ENVIRONMENTAL IMPACT STATEMENT
OF THE
KULAIMANO SEWAGE DISPOSAL SYSTEM

KULAIMANO SEWAGE DISPOSAL SYSTEM
Pepeekeo, Hawaii

(X) FINAL

Comments from Responding Agencies
on the Draft EIS
and Reply to Comments

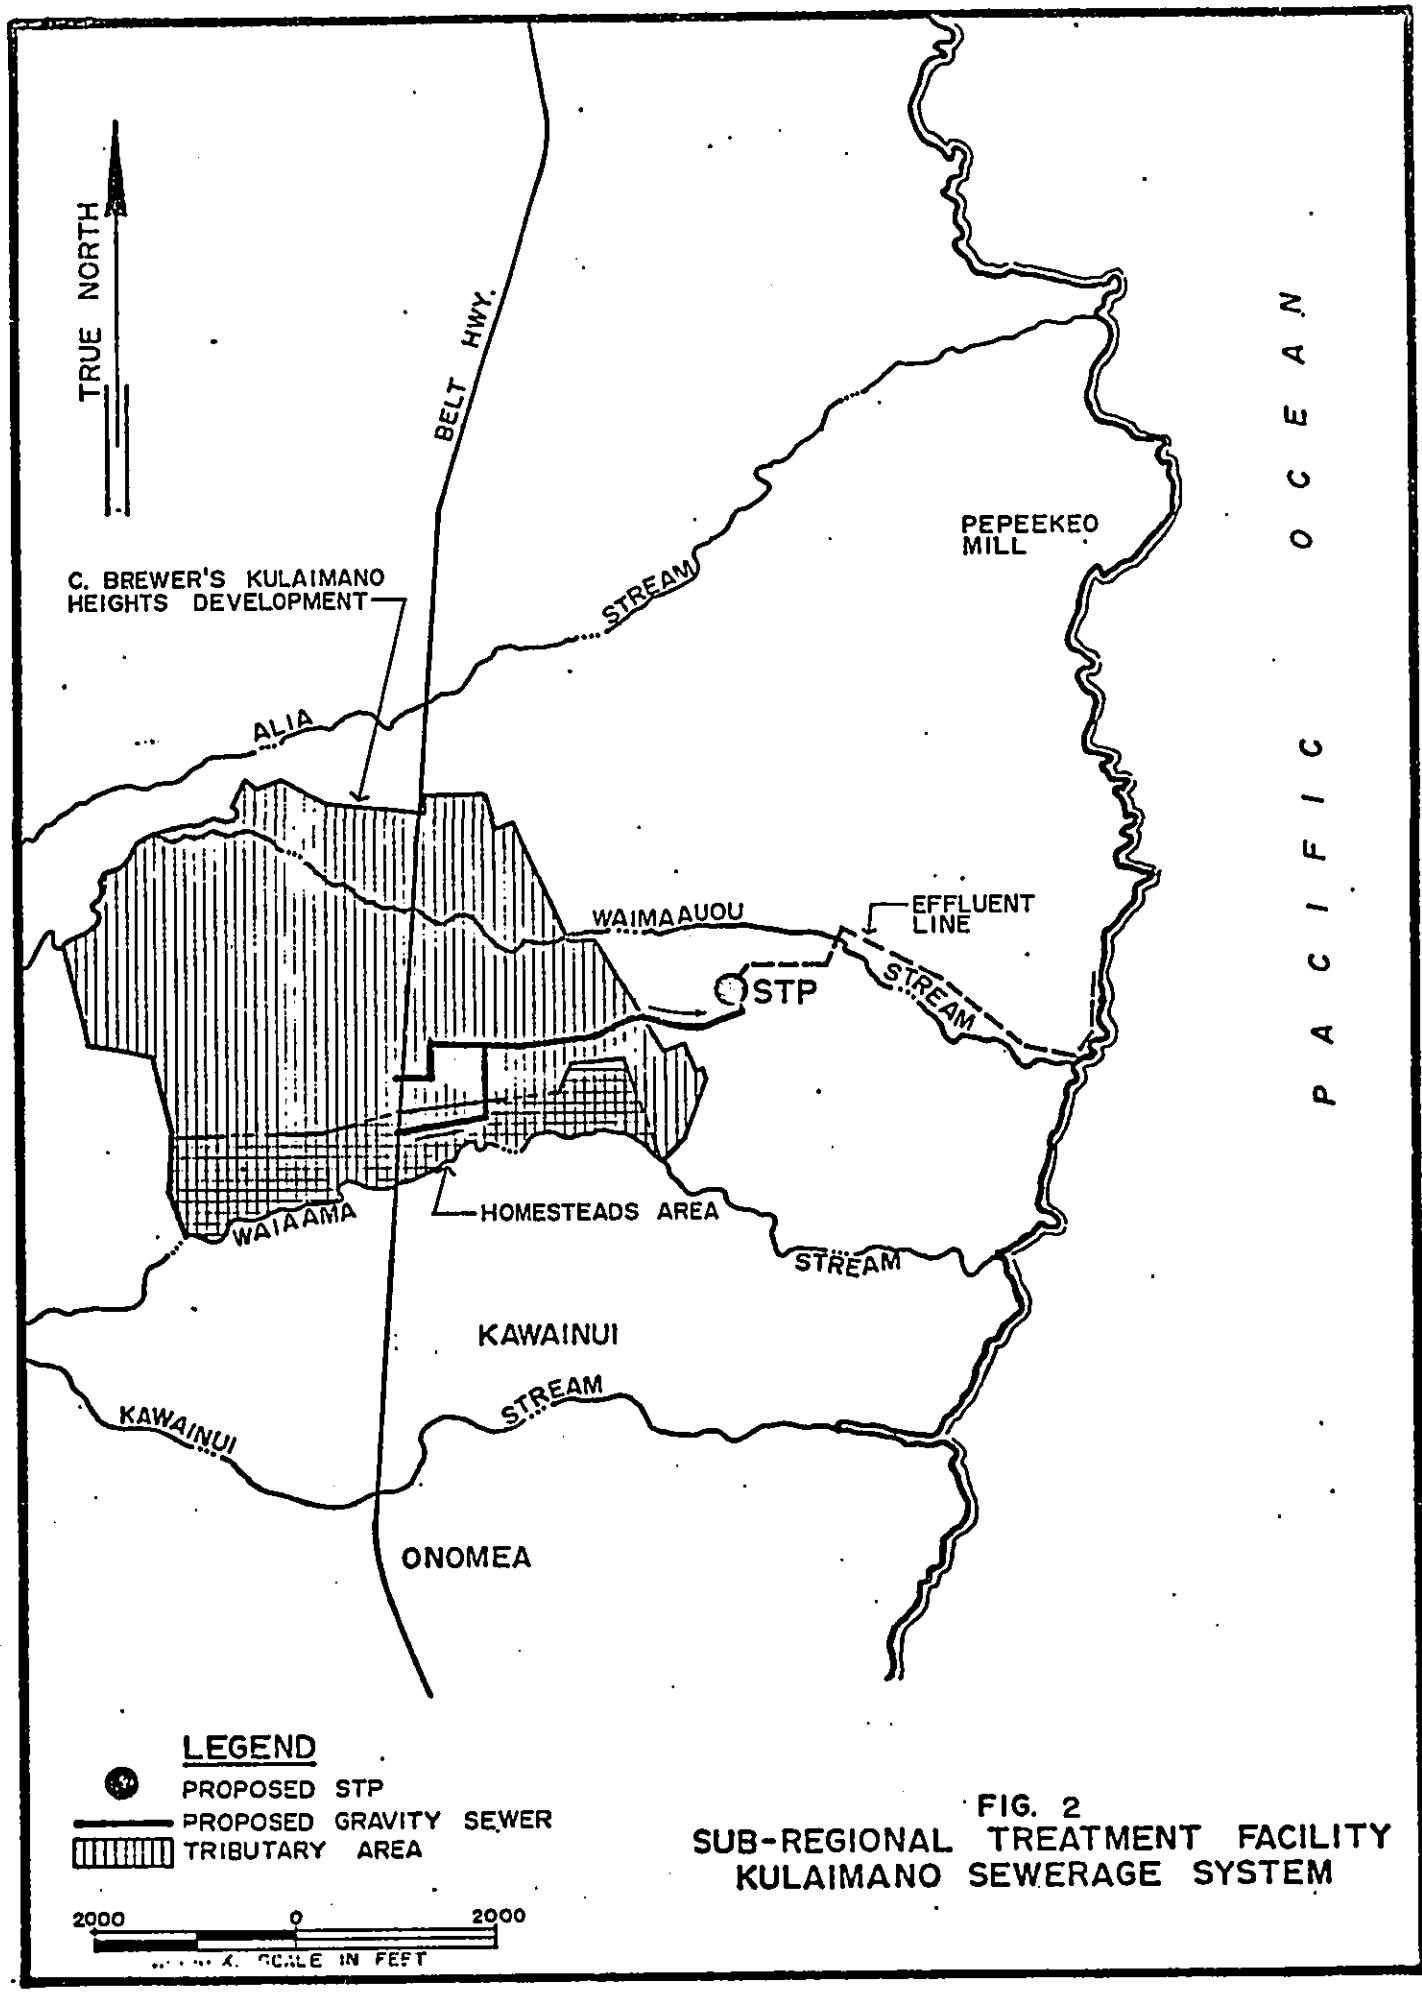
6. Figure 2--Why the peculiar alignment of the effluent line versus a "direct" route via the south side of Waimaaou Stream?

DISCHARGE AREA FOR EFFLUENT
FROM: KULAIMANO STP
NO SCALE

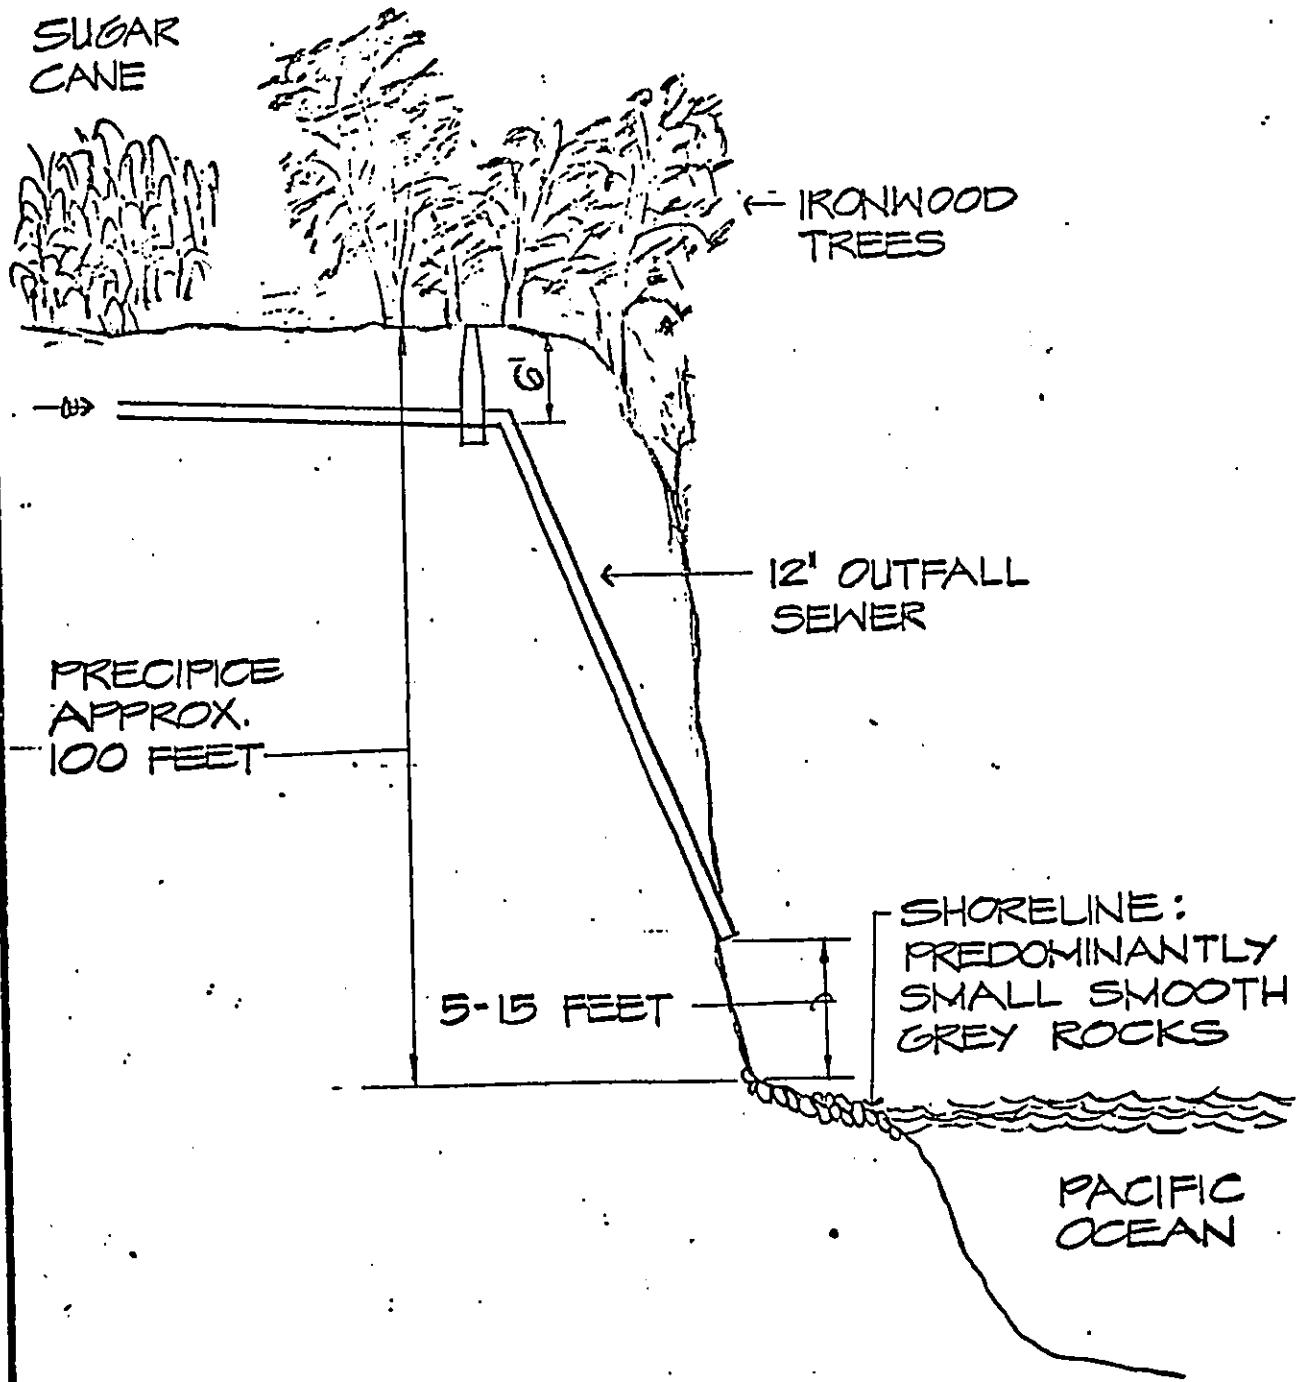
1. Is access to the sewage disposal system readily available? In other words, will roads have to be improved or built?
2. The EIS should include a cross sectional illustration along with an explanation of how the effluent will be discharged over the cliffs and into the surf zone. Further, we agree with the University of Hawaii's Environmental Center that more information is needed in regard to the diameter of the pipeline, distance of discharge from the shore, and the type of surface the discharge will be impacting upon. These details are essential to view the project completely.

The discharge configuration of the outfall is shown on the attached sketch. This was proposed to minimize the aesthetic impact of the discharge, to limit the extent of wind-induced sprays, to minimize the already limited access to the area, and to minimize the extent of erosion of the cliff face.
